ADDENDUM NO. 3

DATE: October 31, 2019

Project: Terre Haute First Baptist Church
Terre Haute, Indiana

ARCHITECT: Dauss Architects
227 W 11th Street
Anderson, IN 46016
Tel: 765.649.2258
Fax: 765.649.2337

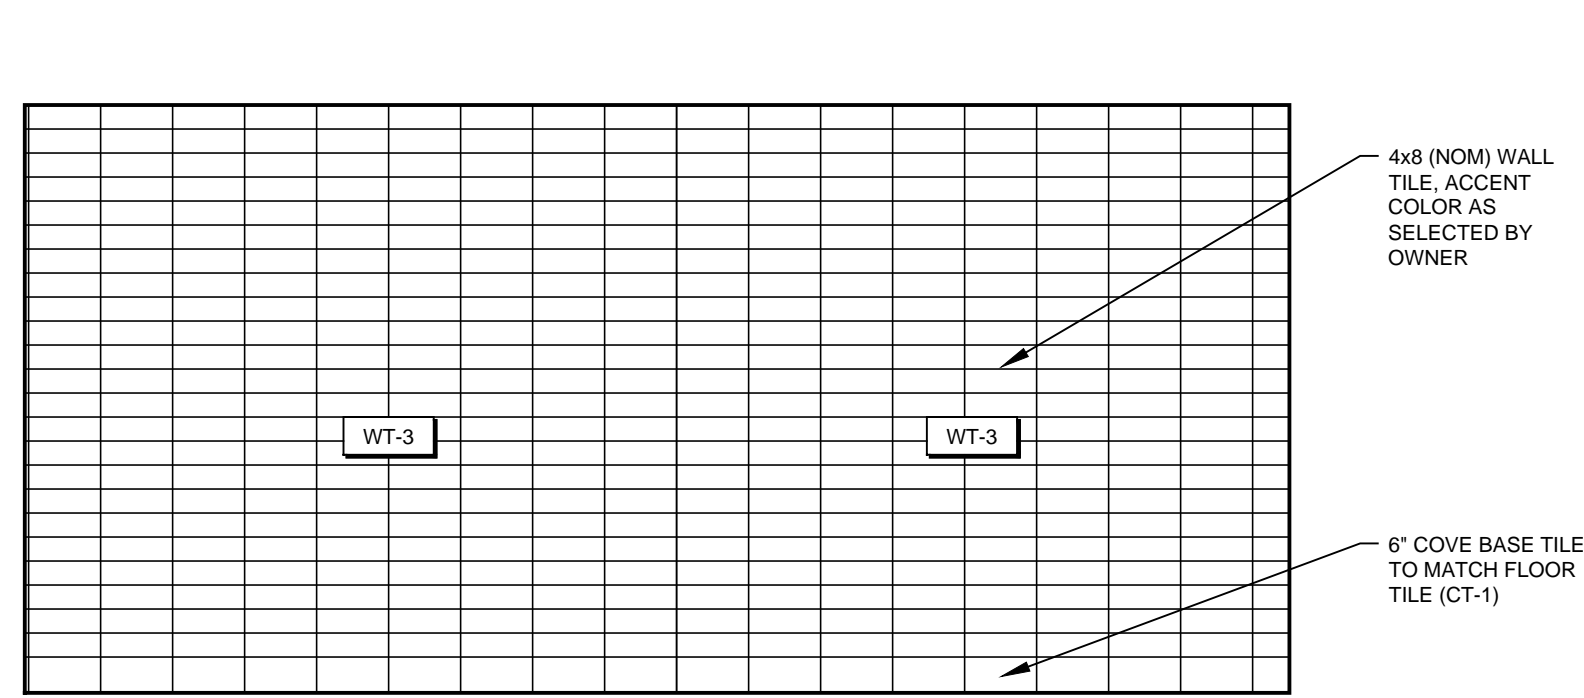
3.17. Elevation A402/2 illustrates the veneer stopping 4' off the corner. But the floor plan shows what appears to be veneer the entire length of CL5 and turning the corner a few feet on CL2 and stopping. I believe the veneer needs to be ran down CL K but want to confirm.

The elevation 2/A402 is correct. The veneer stops 4' past the southeast corner along the east face.

SHEET NUMBER
A309

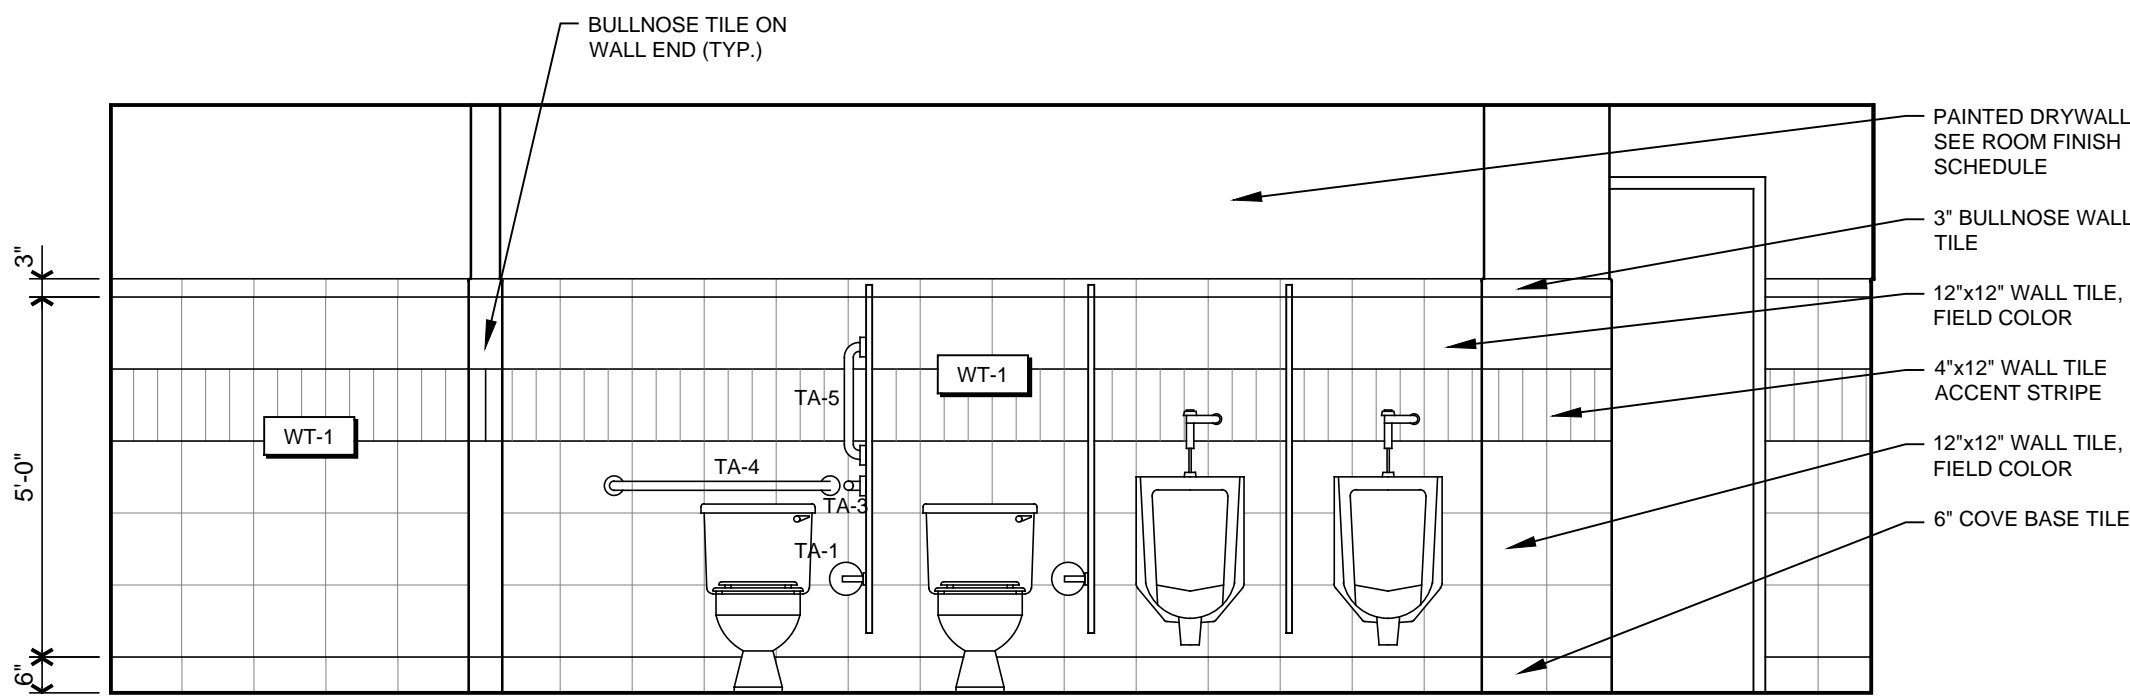
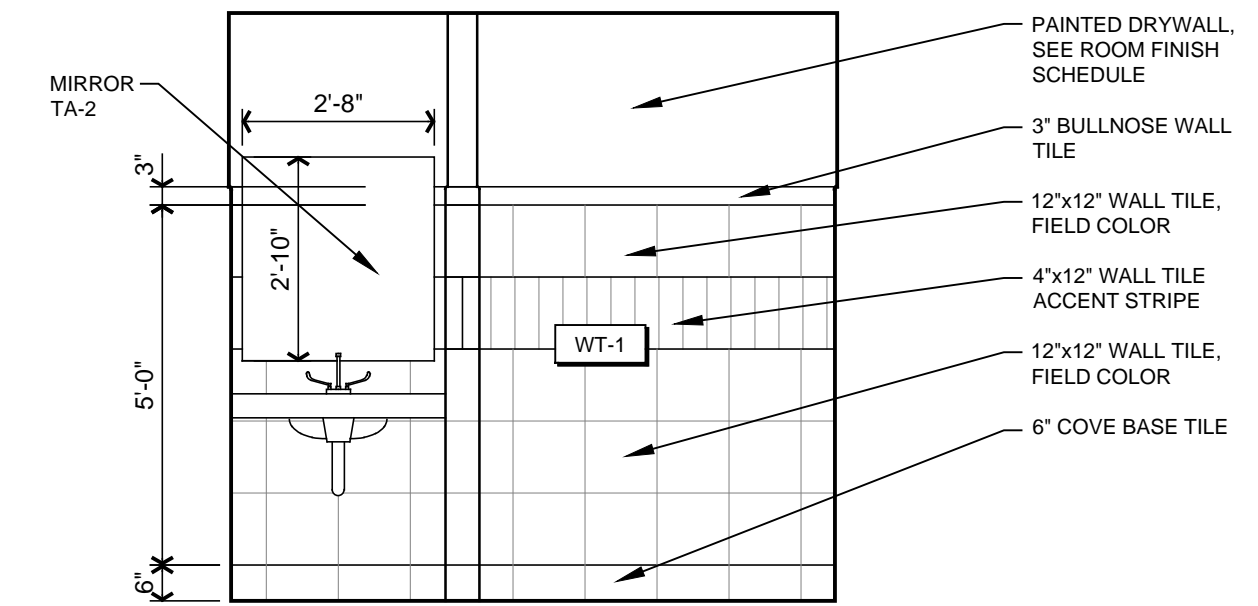
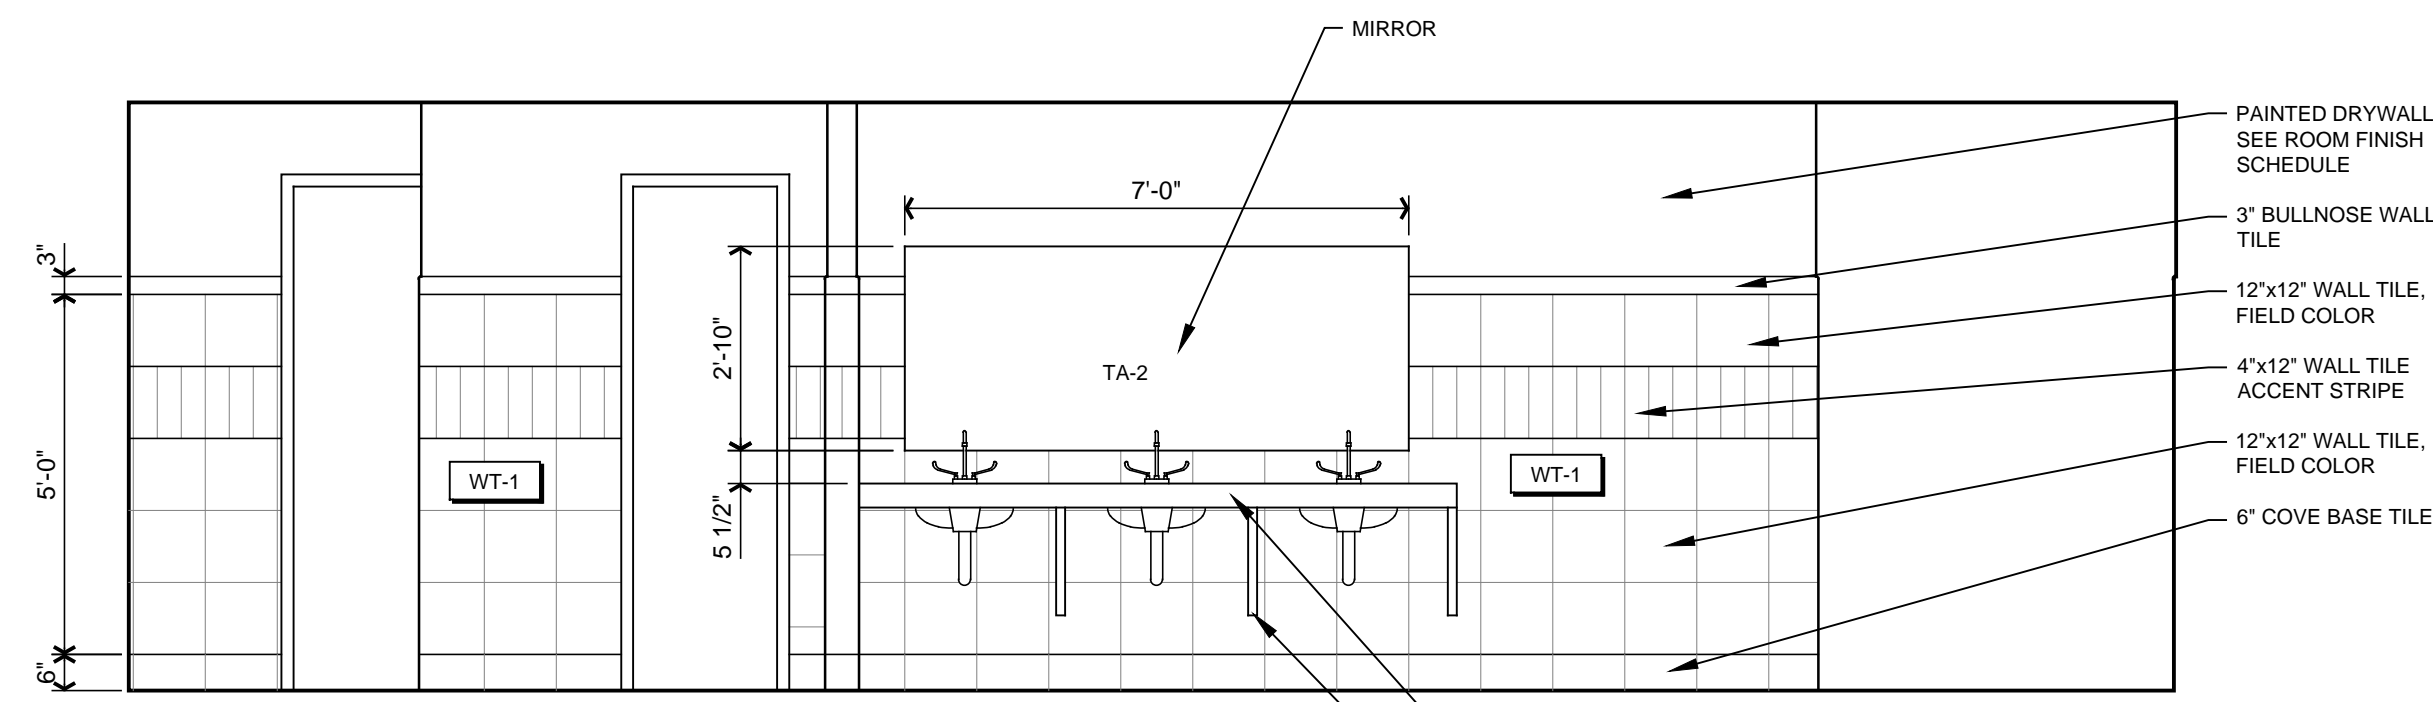
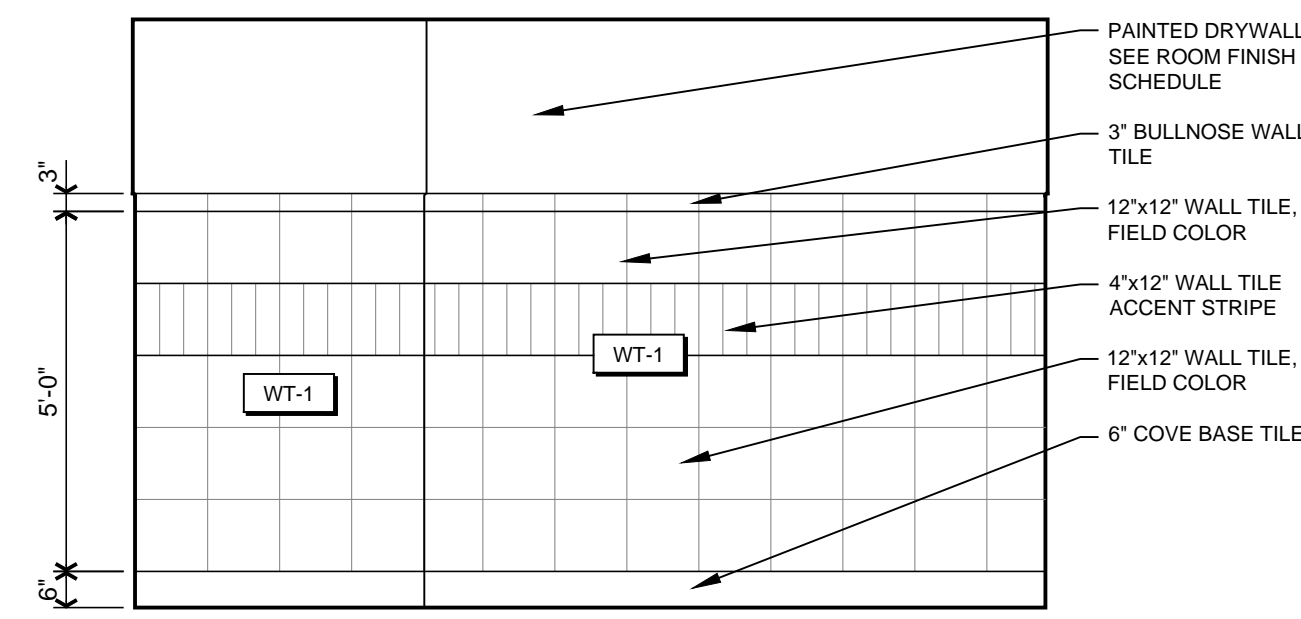
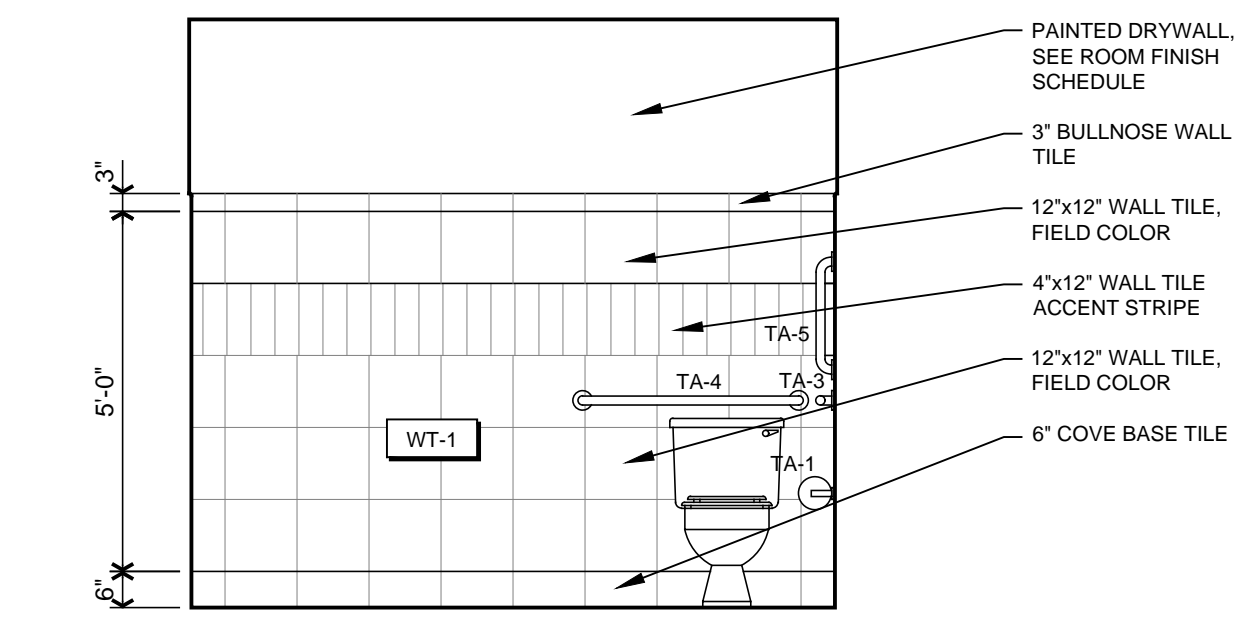
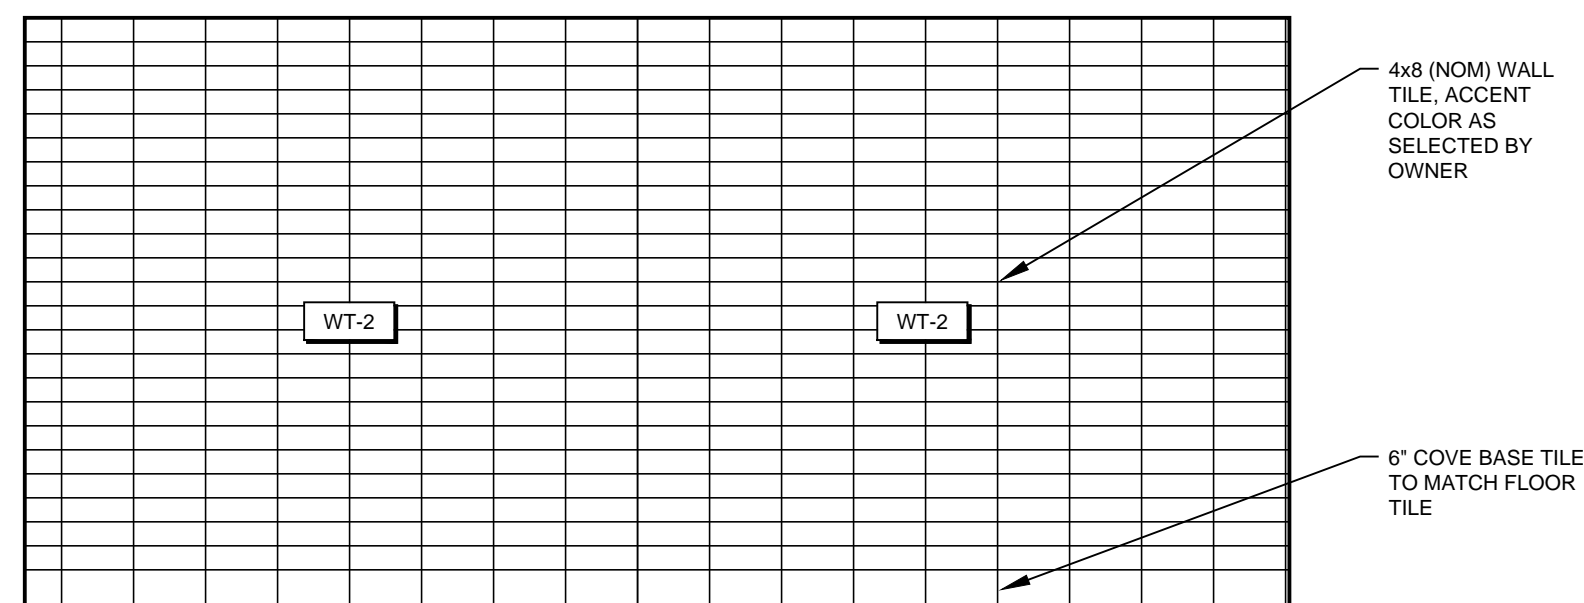
- 3.2. Drawing A205: Change WT-1 to be Daltile "Balans" or approved equal in sizes as shown.
- 3.3. Drawing A206: Revised and forwarded to the plan holders on October 23. The revision included the hardware schedule omitted from the original bid sets. A copy is attached to this addenda.
- 3.4. Drawing A308: Attached as revised to clarify wall tile nomenclature and toilet accessories.
- 3.5. Drawing A309: Added toilet accessory schedule.
